City of Dublin

Minor Project Review

**13-101MPR – BSC Sawmill Center
Neighborhood District**

Covelli Offices – Rite Rug Center

2 EAST ELEVATION
 SCALE: 1/4" = 1'-0"

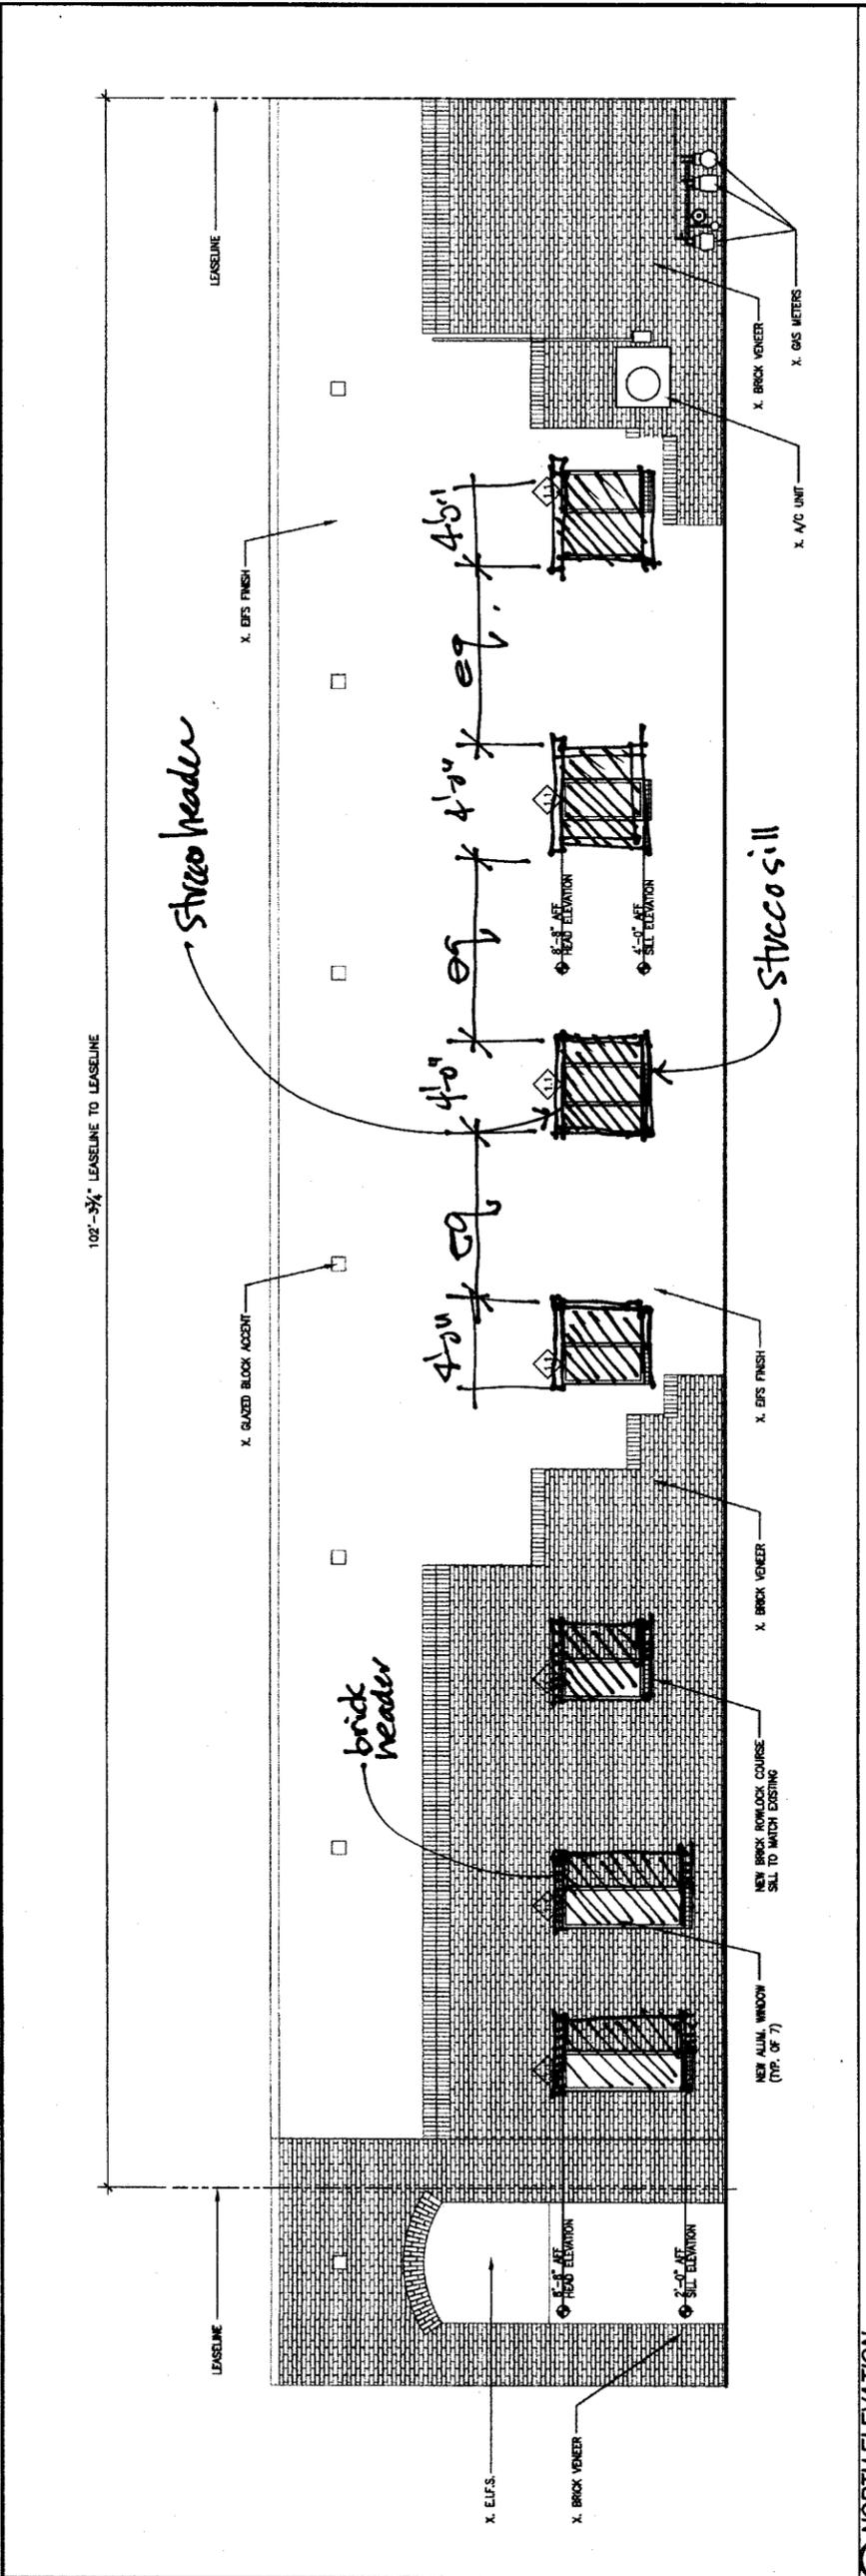
Sheet A-5.1, East Elevation

1. Is the existing stucco sign band to be painted? No indication on the drawings as to the treatment of the existing surfaces.

The applicant will repair the holes left in the sign band from the previous tenant and repaint the Stucco/EIFS material to match existing. No signs are proposed at this time; new signs will require a separate Minor Project Review application.

3 NORTH ELEVATION
 SCALE: 1/4" = 1'-0"

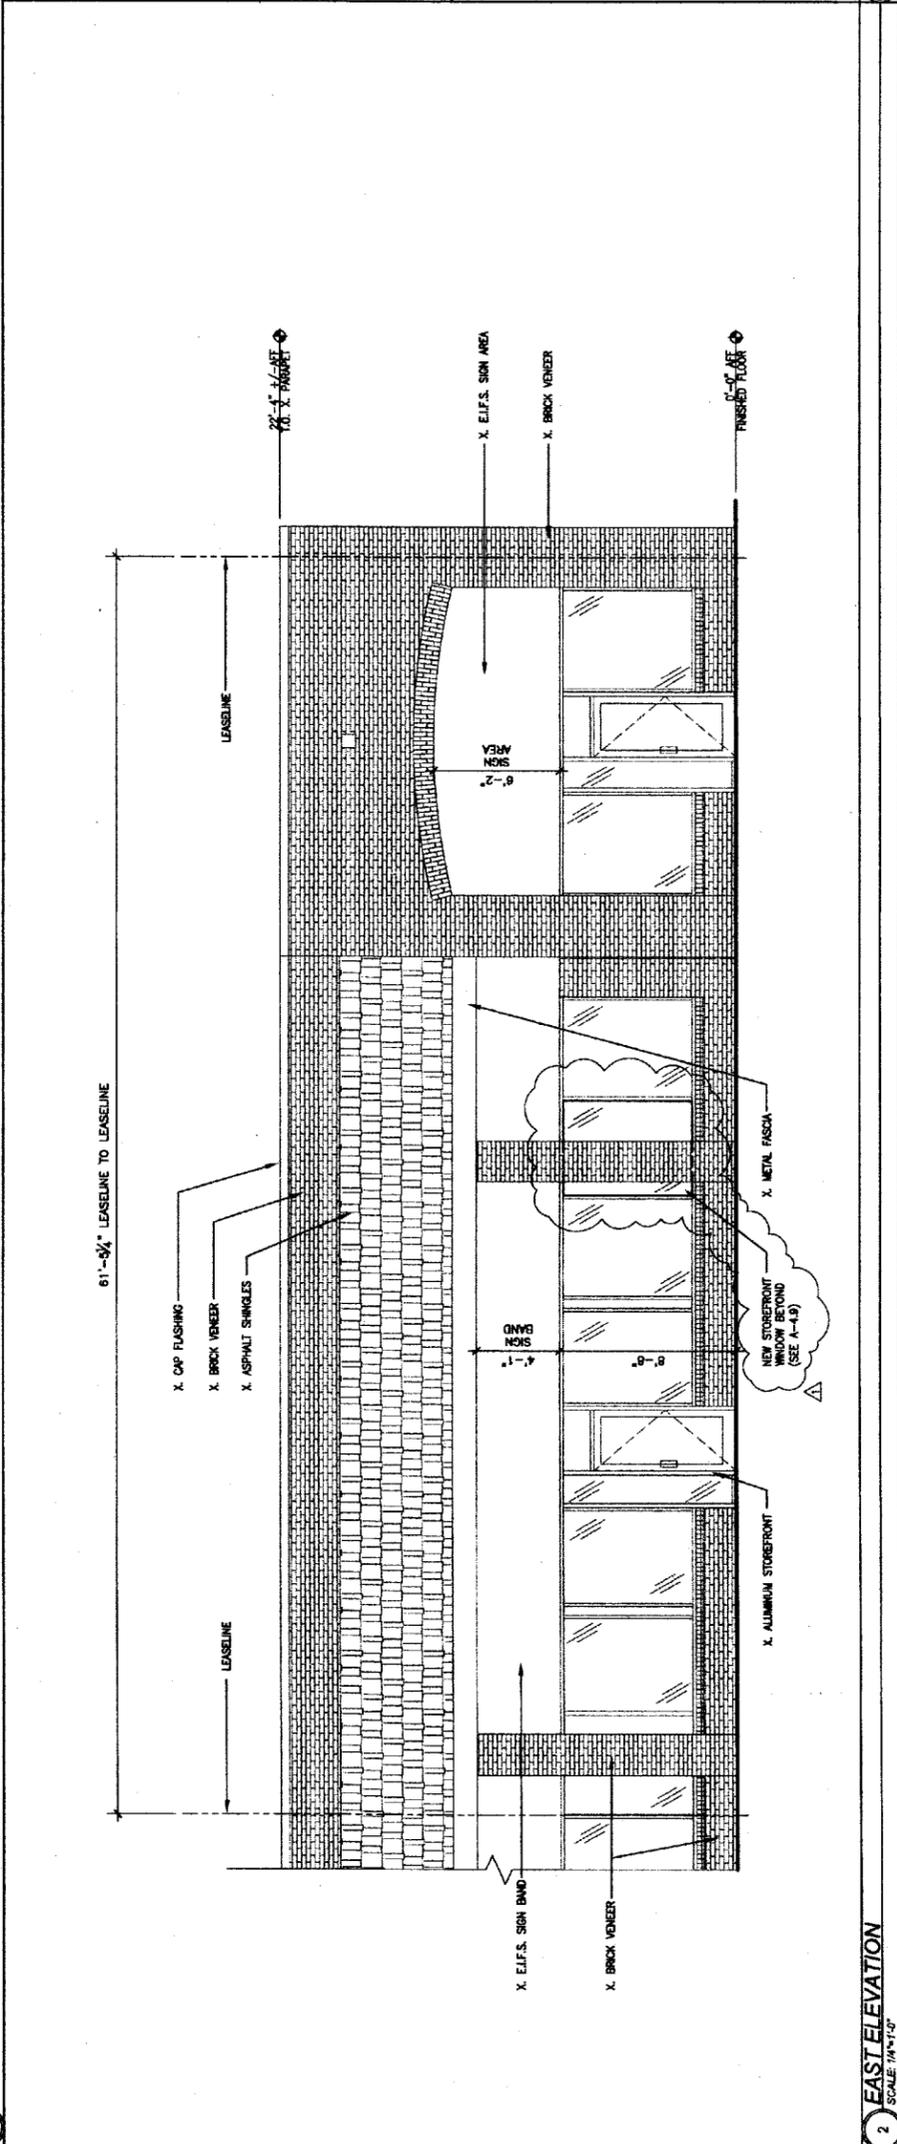
Sheet A-5.1, North Elevation

1. The drawings indicate that the wall surface is EIFS; however, I believe that the existing material is cement stucco.
2. I would recommend that the width of each window unit be increased to a minimum of 4 feet in width.
3. The spacing between the individual windows varies (See Plan Dimensions on Sheet EC-2.1). The spacing between the window units should be consistent. See attached sketch.
4. At the window openings located in the brick field, a brick soldier course header should be provided.
5. Provide an accent header and sill at the top and bottom of each window opening in the stucco field.
6. There is a large crack in the existing stucco finish that should be repaired as part of this construction.

North Elevation

- The proposed windows on the north elevation have been increased from two feet to four feet in width.
- Window spacing has been adjusted to provide equal spacing between the (five) four foot-by-four foot office windows. Alternate spacing is provided for the (two) four foot-by-six foot conference room windows to accommodate interior design elements. Planning is concerned that one of the four-by-four windows within the stucco field is positioned too close to the brick veneer field. Planning recommends shifting all five office windows one foot to the west to provide better spacing between the brick and stucco façade areas. Based on the proposed floor plan, this recommendation appears feasible without creating internal conflicts.

- Brick sills and headers are provided for the windows located within the existing brick field.
- Stucco sills and headers are provided for the windows located within the existing stucco field.

- A visible crack in the existing stucco finish will be repaired, along with any other necessary repairs to existing materials that may be discovered as work is performed.
